APPLICATION: 18/0301/REV
APPENDIX E - HIGHWAYS, TRANSPORT & DESIGN COMMENTS

INTERNAL MEMORANDUM
 Highways, Transport & Design

Proposal: Revised outline planning permission with some matters reserved (appearance, landscaping and layout) for the erection of residential development, associated infrastructure including access road and public open space	Date:	14/05/18		
Location: Hunters Rest Farm, Urlay Nook Road, Eaglescliffe	Ref:	18/0301/REV	Rev	1

Plan 1 - Allens West (11/2842/EIS) – Proposed mitigation at Urlay Nook Road / Durham Lane / Elton Lane / Tesco roundabout

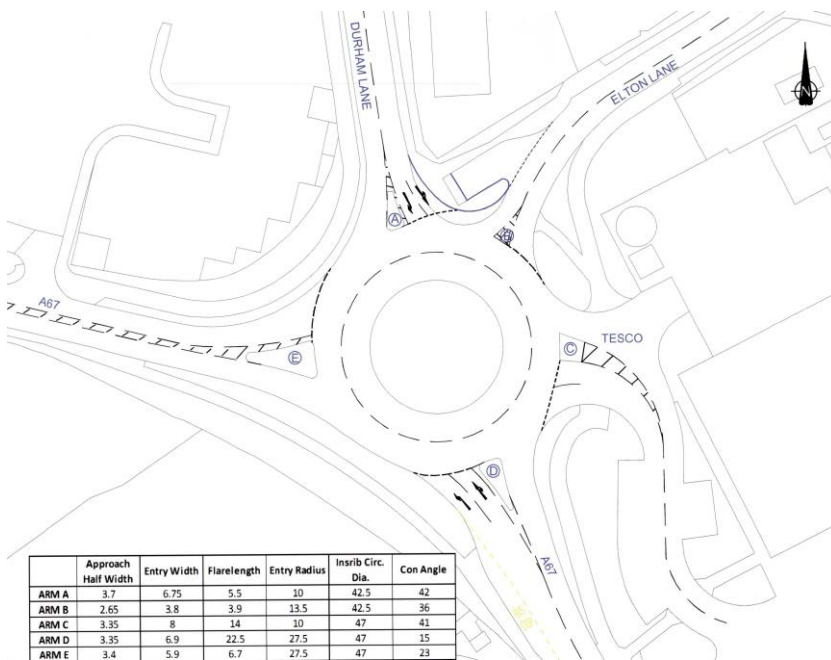
Therefore, notwithstanding the junction assessment reported above, the Highways, Transport and Design Manager has tested the proposed mitigation at the Urlay Nook Road / Durham Lane / Elton Lane / Tesco roundabout, associated with the extant planning approval for Allens West (11/2842/EIS) as shown on Plan 1 below, to ascertain if this has any benefit when considering the impact of the proposed development.

The journey time results demonstrate that the mitigation, associated with the Allens West development (11/2842/EIS), would have a beneficial impact when considering the proposed development. It is therefore reasonable to request that mitigation is brought forward by the proposed development, should the proposals be approved, this should be secured via a s106 Agreement.

Plan 2 - Allens West (11/2842/EIS) – A66 Elton Interchange mitigation

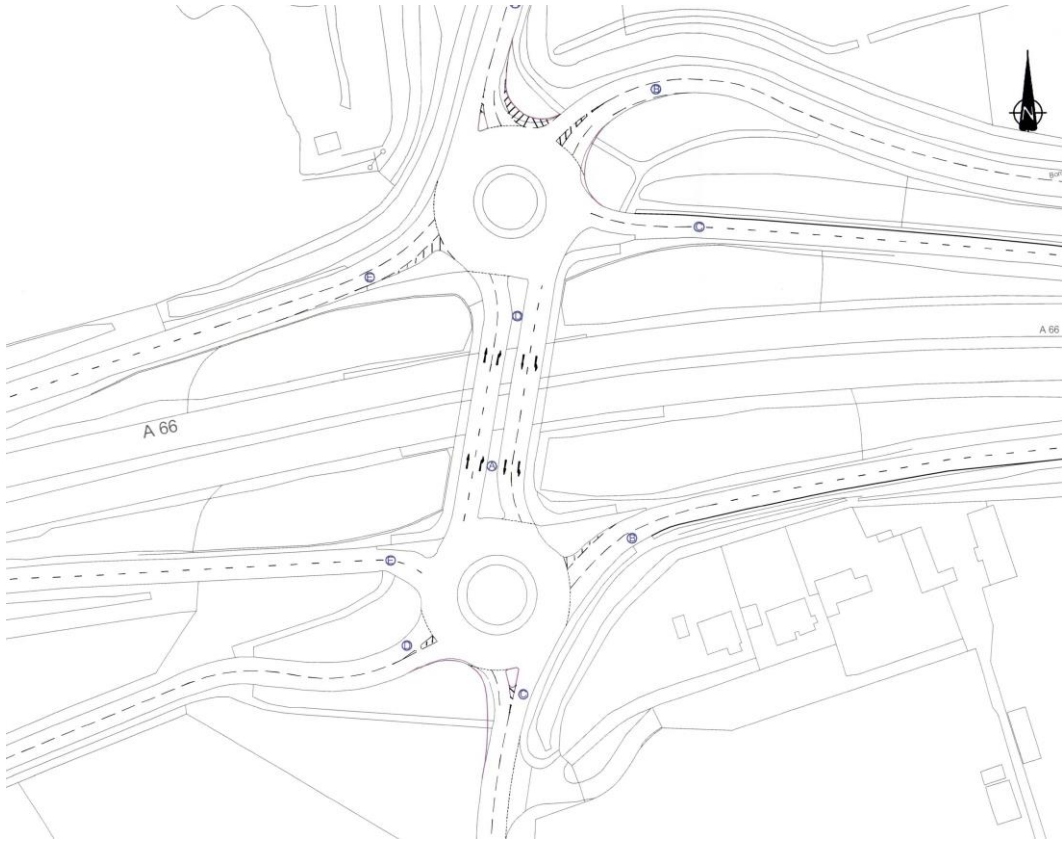
The proposed mitigation will bring forward a scheme that fully takes account of the extant permissions that are already reliant upon improvements at this junction namely:

The works would further increase the length of the two lane entries to the A66 Elton Interchange junction at the following locations:

- Yarm Back Lane by 1.5m;
- Darlington Road (north roundabout) by 1.0m;
- Durham Lane by 4.0m.

These works, which take account of the works required by the extant approvals, will be secured through a s106 Agreement.
